COLLINS RADIO COMPANY

30S-1 RF LINEAR AMPLIFIER

SERVICE BULLETIN NO 3

REDUCE EXCESSIVE ALC CONTROL

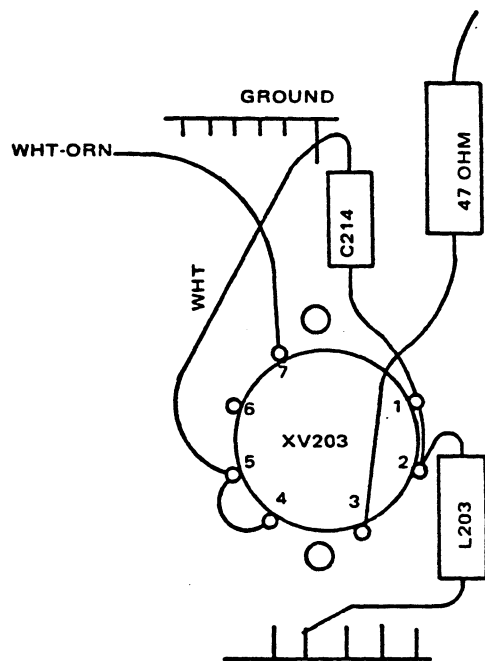
In order to determine if your unit has this modification installed, observe the top side of relay shelf to locate the tube and socket for V203 which is adjacent to CR205 and CR207 on the right and toward relays K203 and K202. If type 12AL5 tube V203 is present the 30S-1 has not been modified.

30S-1 SB 3 Modification, Components -- Wiring Locations
Figure 1

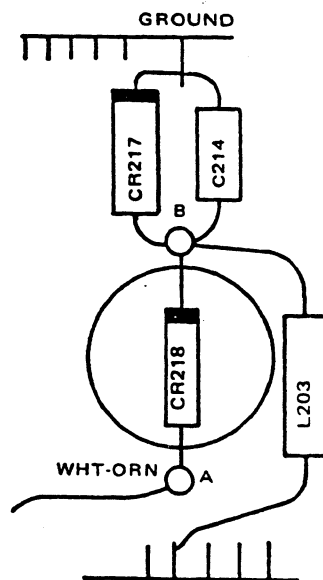
30S-1 units originally employed a 12AL5 dual-diode as the alc rectifier, V203. Some production runs of this tube exhibited high space-charge characteristics resulting in objectionable high standoff voltage on the alc line. The method recommended to ensure proper alc operating voltage is to substitute 1N457 silicon diodes for the tube.

3. Remove and discard white wire from XV203 pins 4 and 5 to terminal strip ground.
4. Remove securing hardware and lift socket XV203 out of the way.
5. Install two terminals A and B (306-0234-000) in removed XV203 socket mounting holes with screws (343-0285-000) and washers (373-8010-000).
6. Disconnect white-orange wire (from J202) at XV203-7 and reconnect it to terminal A.
7. Disconnect L203 lead from XV203-2 and reconnect to terminal B.
8. Disconnect C214 lead from XV203-1 and reconnect to terminal B. Discard XV203 that is now free of circuit.
9. Install 1N457 diode CR218 (353-0204-000) from terminal A to terminal B (banded end).
10. Install 1N457 diode CR217 (353-0204-000) from terminal B to terminal strip ground (banded end).

11. Replace shelf and R207 to unit and restore power removed in step 1. Check the amplifier for proper operation.
12. Mark SB 3 on information chart (280-3778-010) and apply to an appropriate location on the outside of the unit if it is your wish to identify unit as modified.

30S-1 SB 3 Modification, Schematic Diagram, Partial View
Figure 2

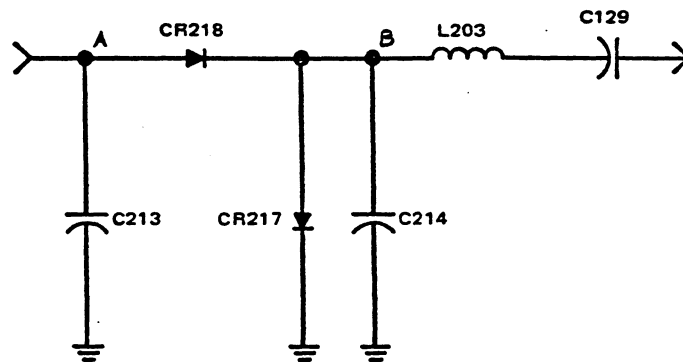
NOTE: Figure 2 is a schematic presentation of the modification.
